## CLARK COUNTY, NEVADA BID NO. 603123-13 ADA SIDEWALK RAMPS

### ADDENDUM NO. 1

DESIGNED BY:	R. Falcon / Bob	SCALE:	NA	SHEET NO.	3
DRAWN BY:	Bob	HORIZ:	NA	PROJECT NO.	130316A
CHECKED BY:	R. Falcon	VERT:	NA	L-2001	
DATE:	Nov 15, 2013 - 4:12pm	FIELD BOOK:	NONE	WORK ORDER:	DD07-0005

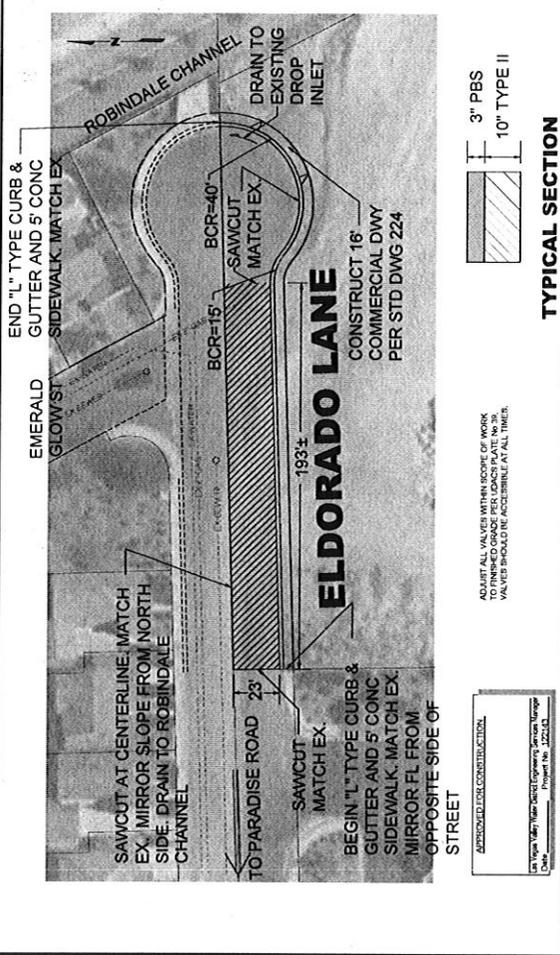
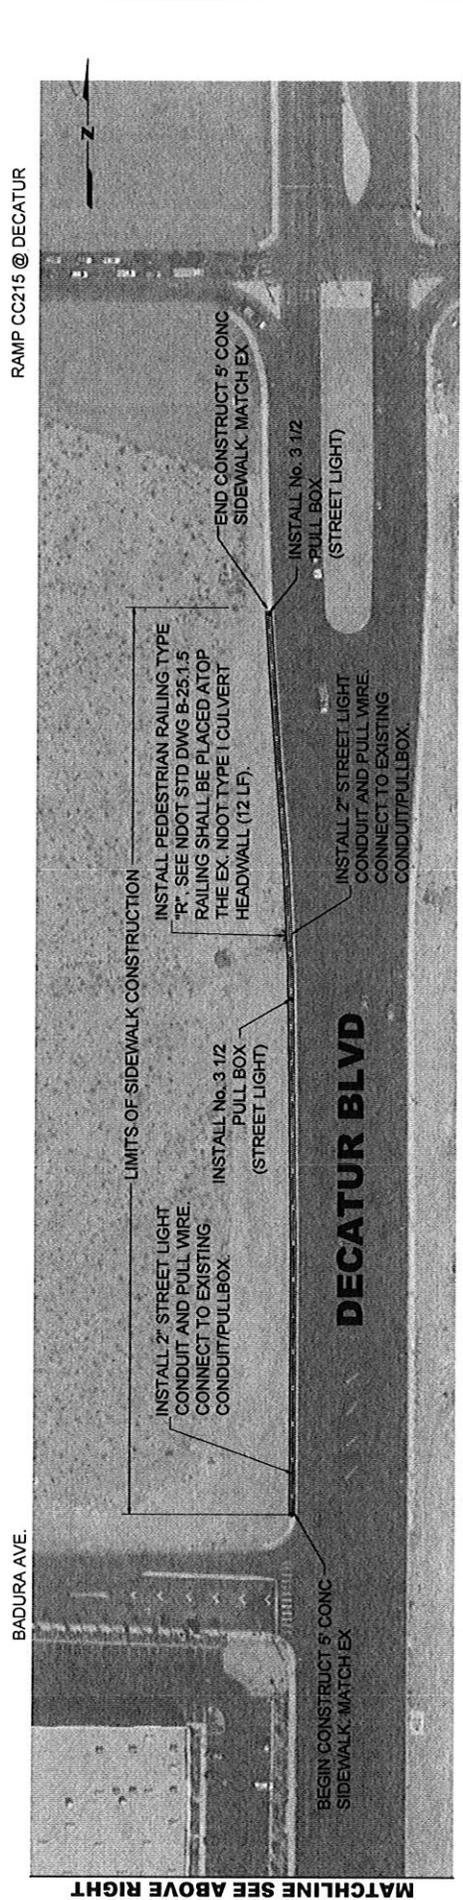
6. SHEET NO. 3

- a. Adjusted the location of the No. 3 ½ Pull boxes.
- b. Removed installation of 4" conduit and P30 pull boxes.
- c. Added installation of NDOT Type R Pedestrian Rail on top of existing culvert headwall.
- d. Added dimension of width of pavement (23') on Eldorado Lane.
